# **PRELIMINARY & FINAL DRAINAGE REPORT**

## **ABERT RANCH SUBDIVISION**

March 27, 2017  
Revised November 16, 2017  
Revised April 5, 2019

**JPS Project No. 111604  
PCD File No. SP-17-007**

Culvert F

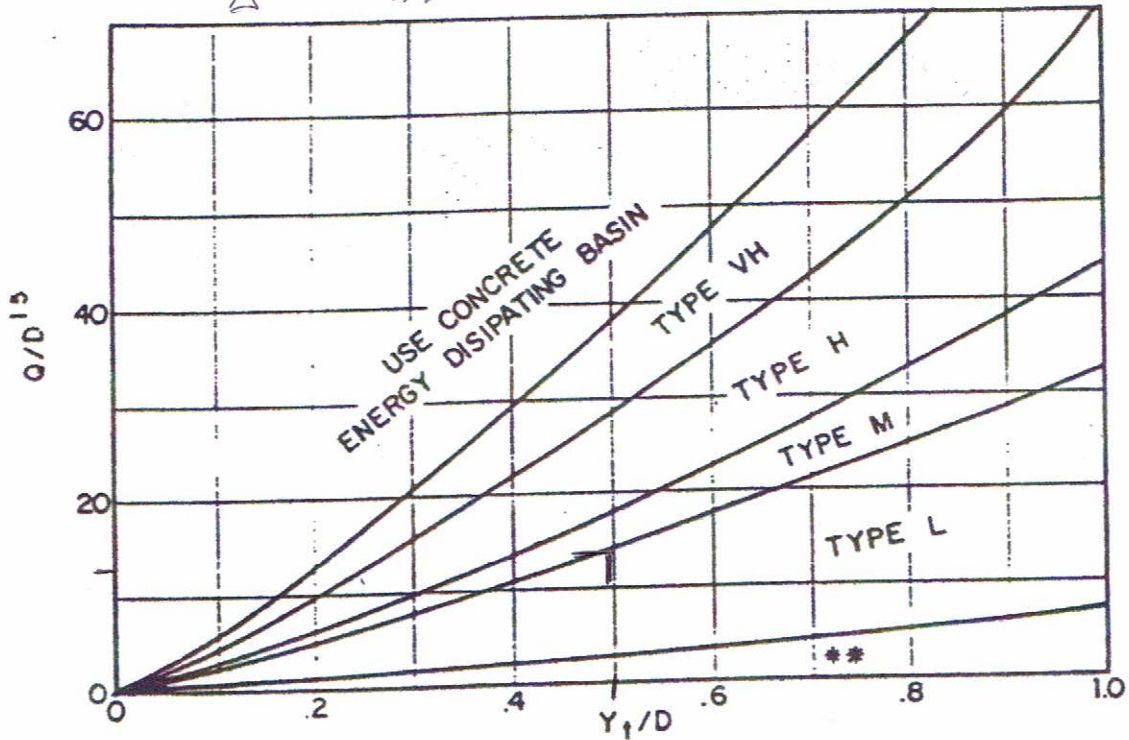
This calculation only provides the size of riprap. Please provide calculation for the required length/width, typical.

Detention Pond I - Outlet Pipe

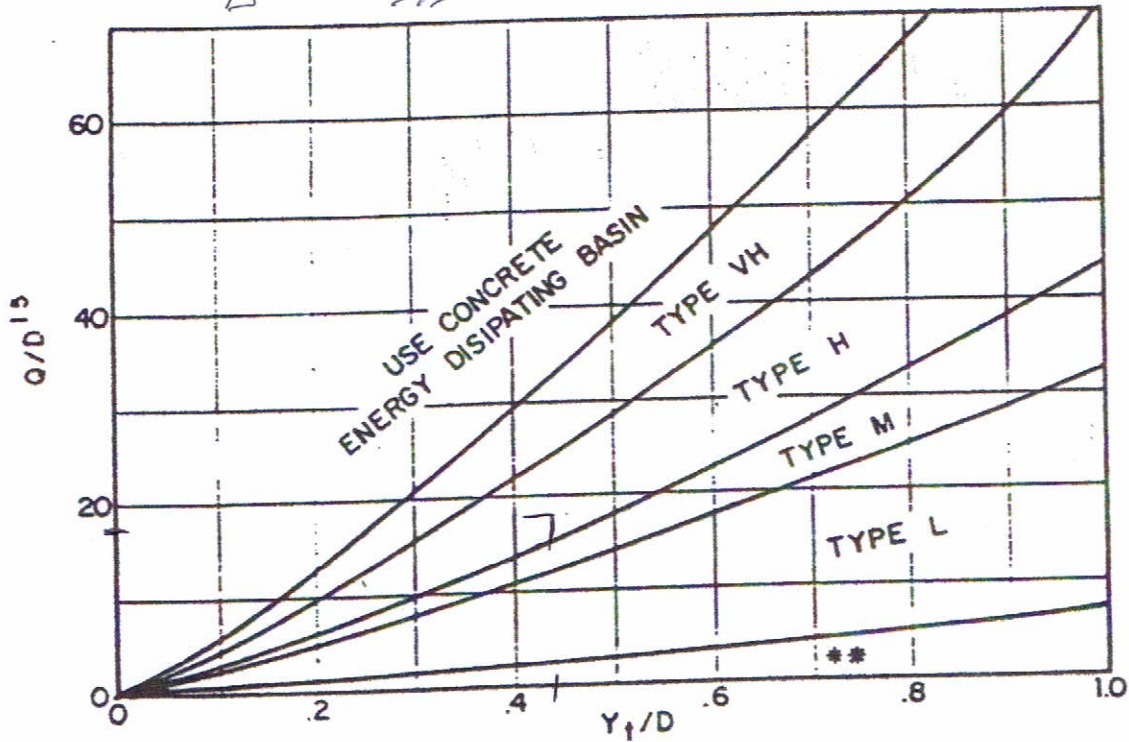
UD Detention calculation and other calcs. indicate that the 100 yr flow is 125.1 cfs. Revise accordingly.

### Routed Hydrograph Results

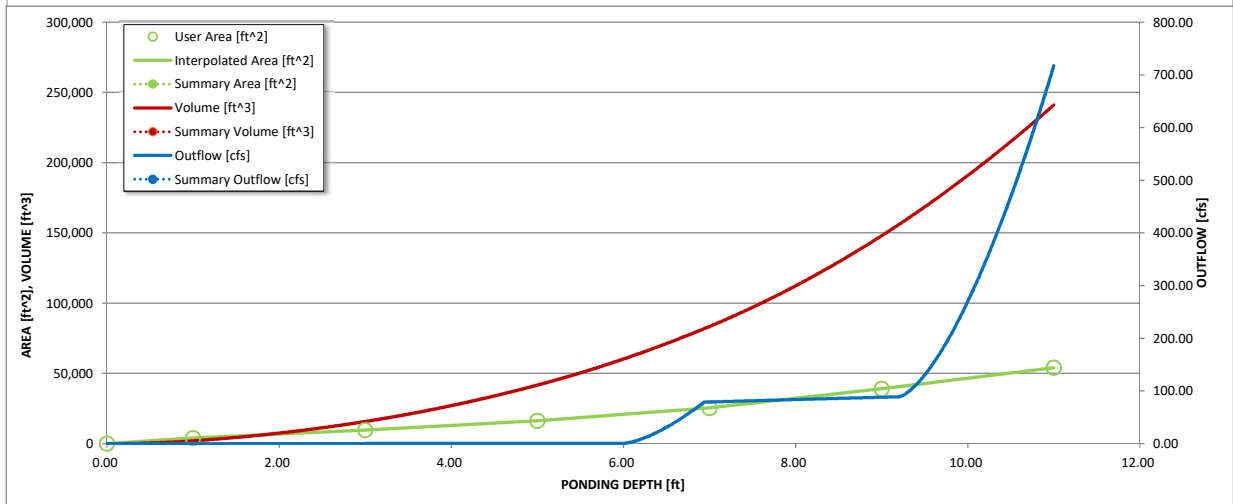
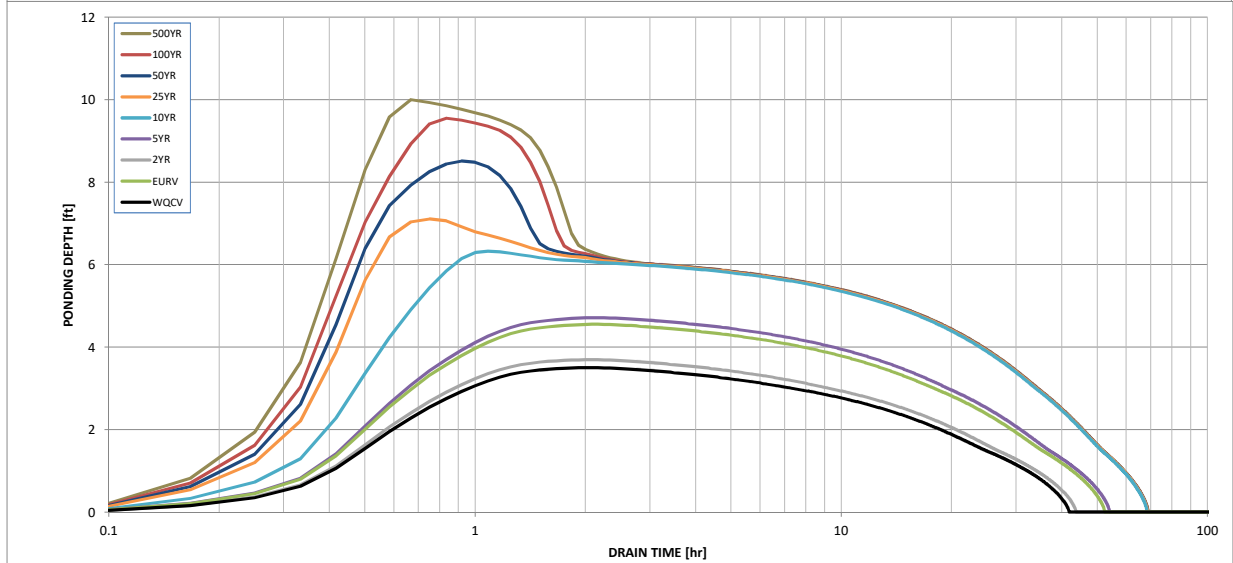
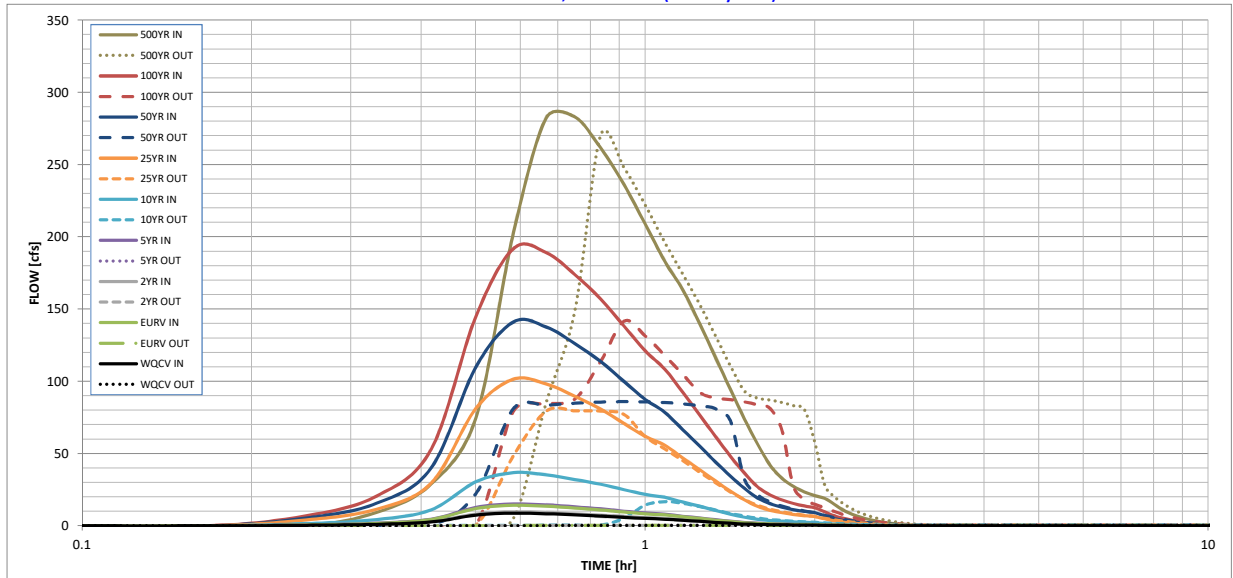
Revise the outlet structure so that it does not go through the emergency spillway and through the outlet plate.

SHEET: **EX1**

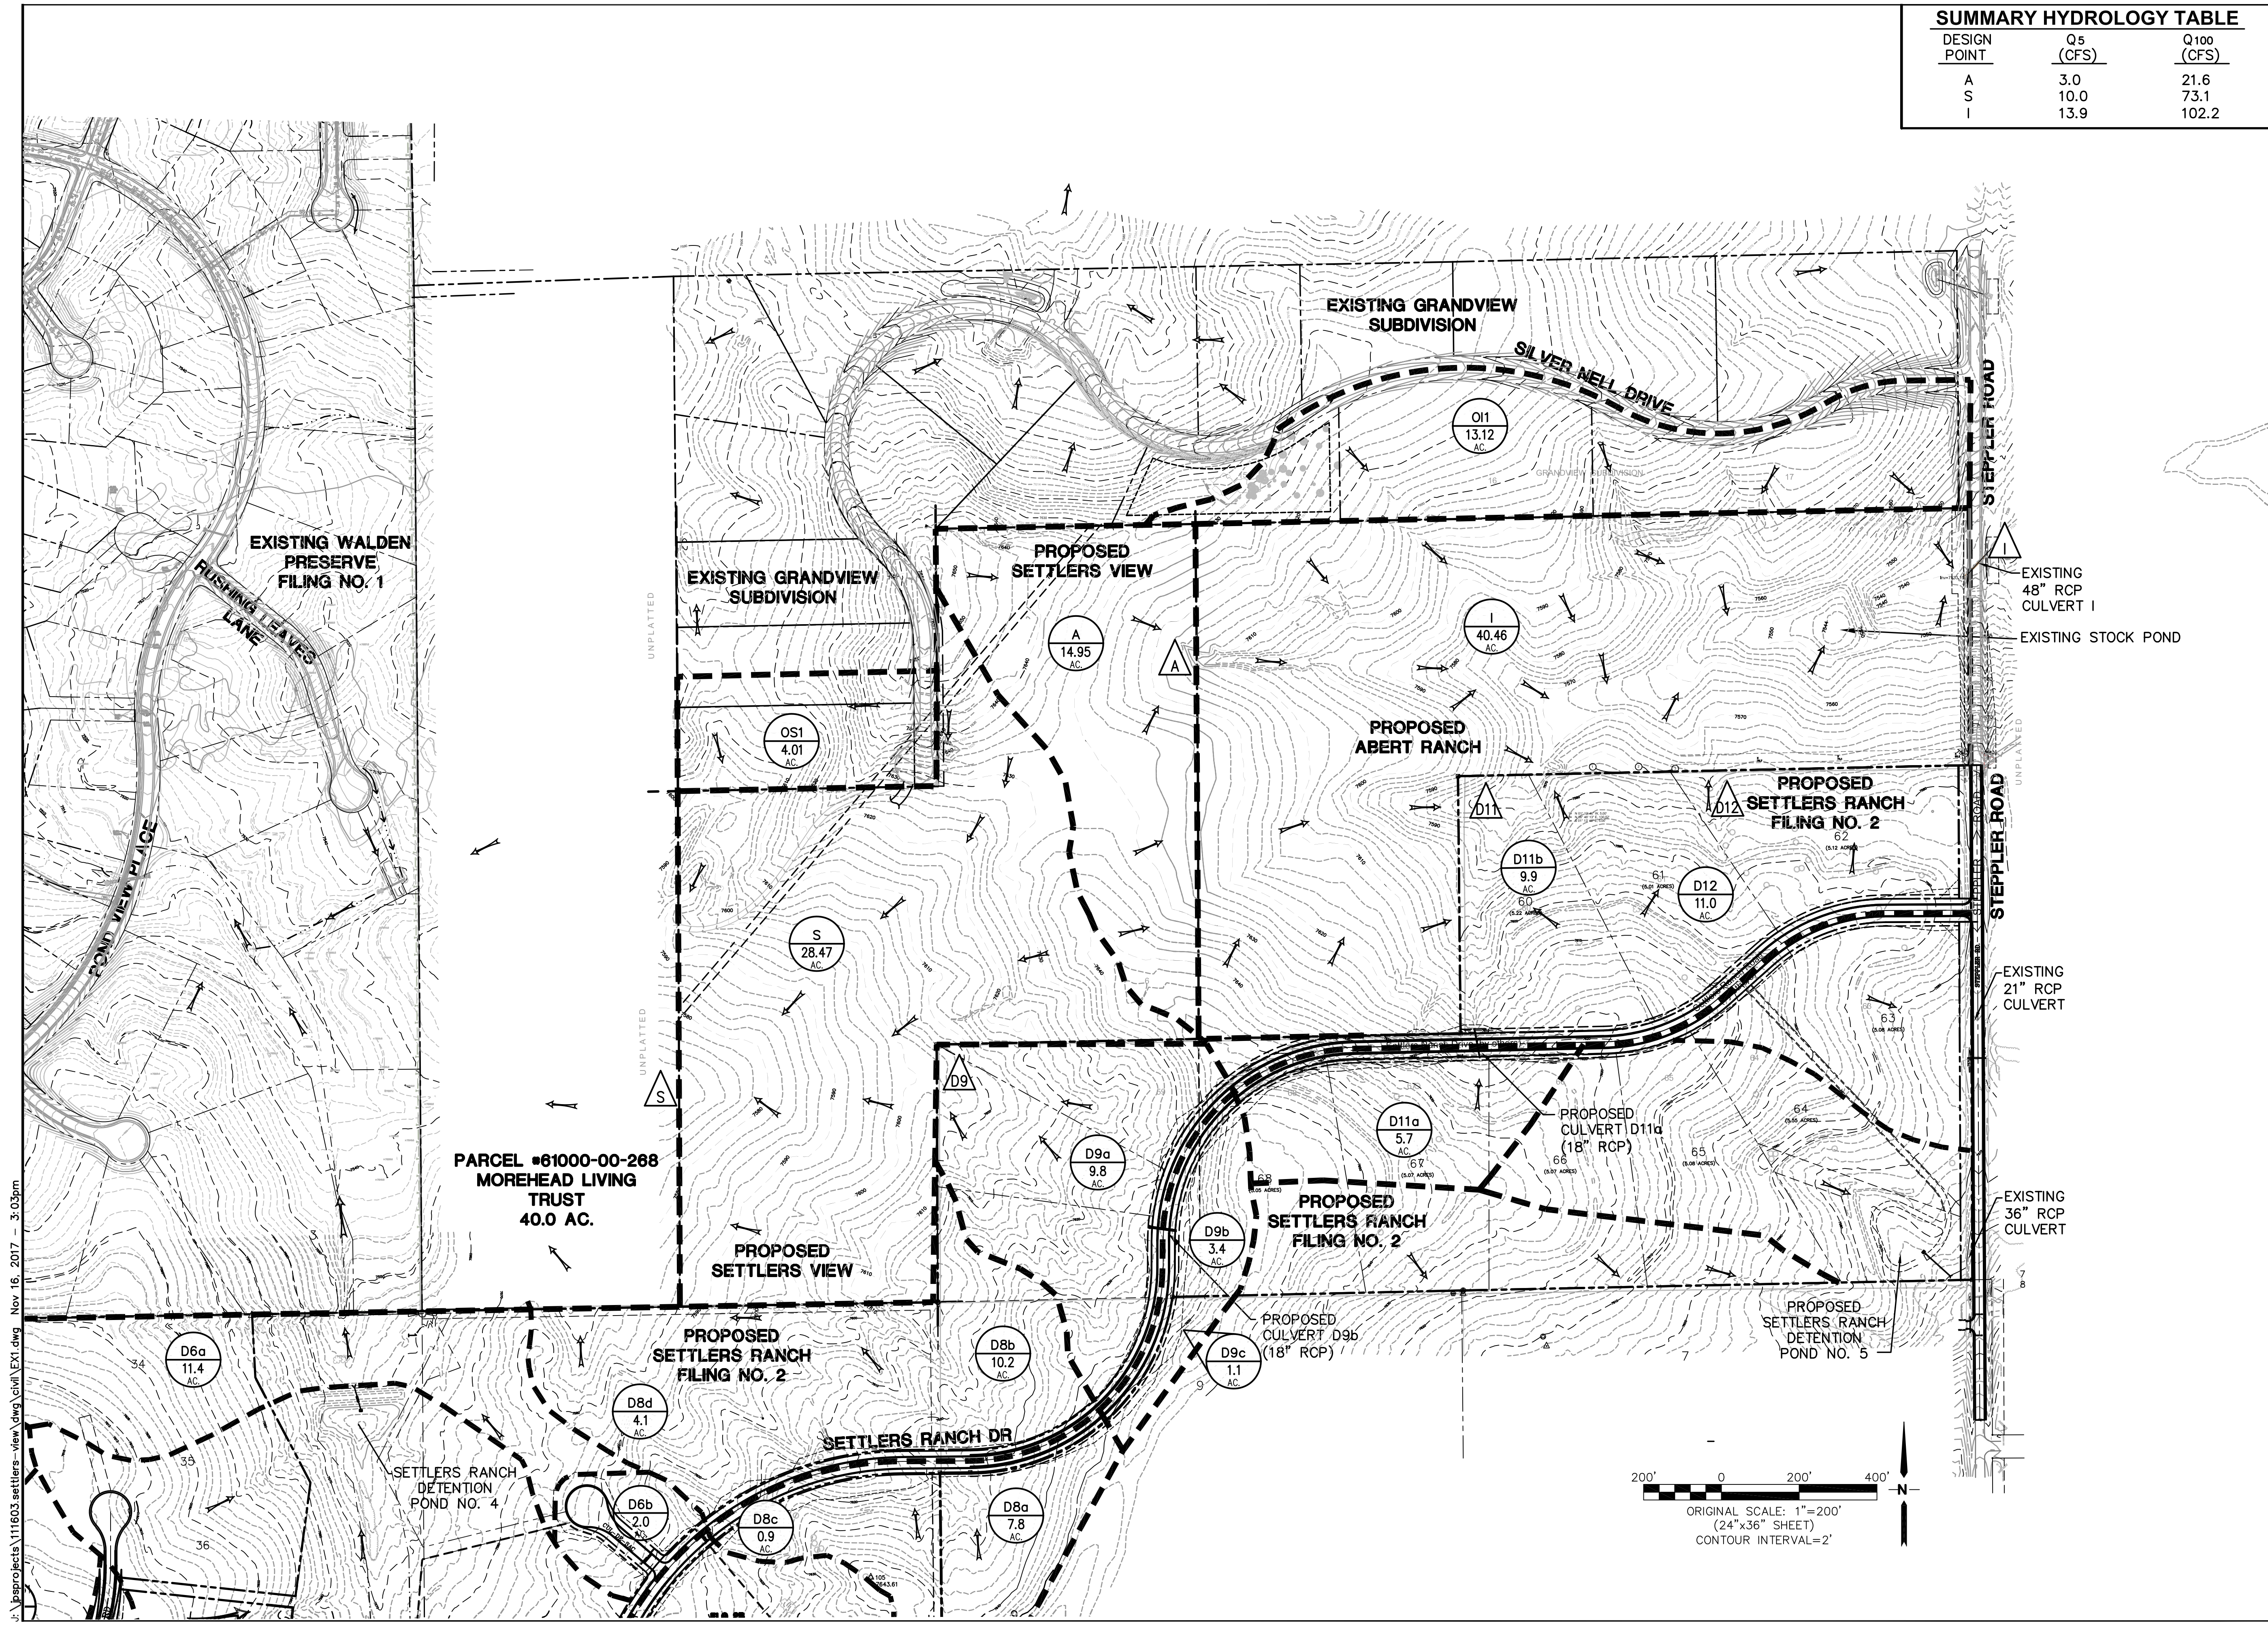
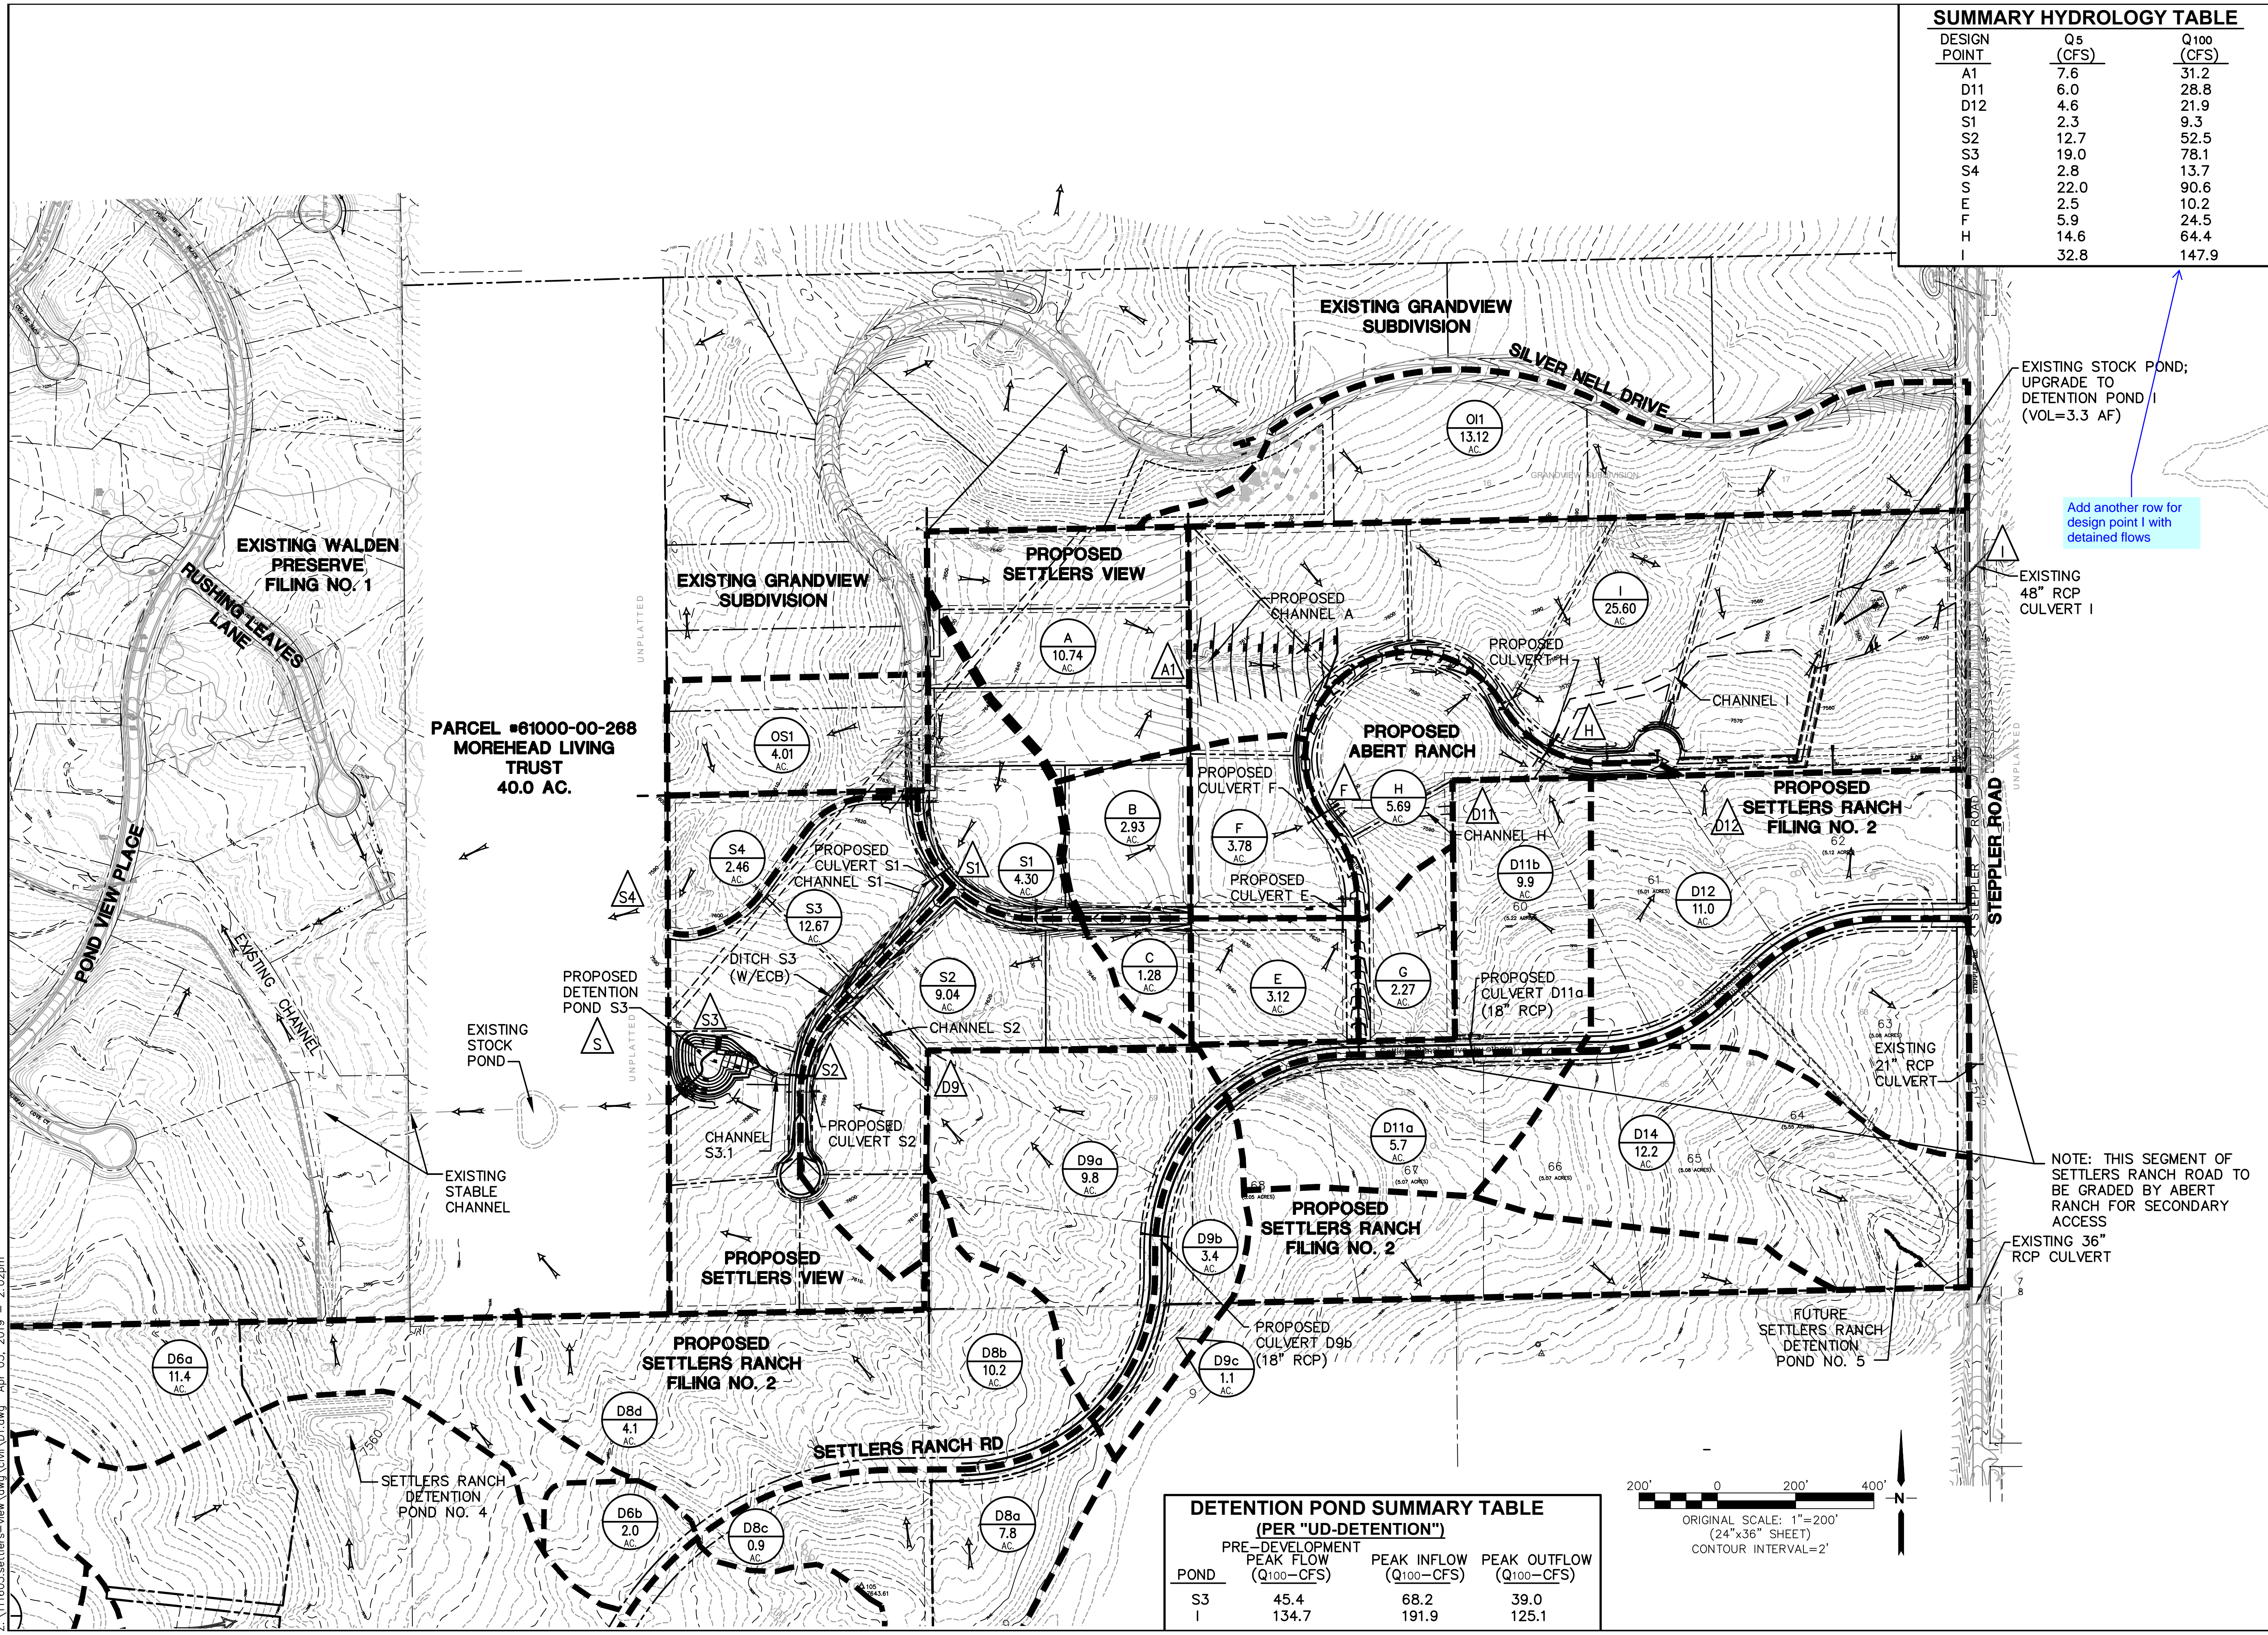
Add another row for design point I with detained flows
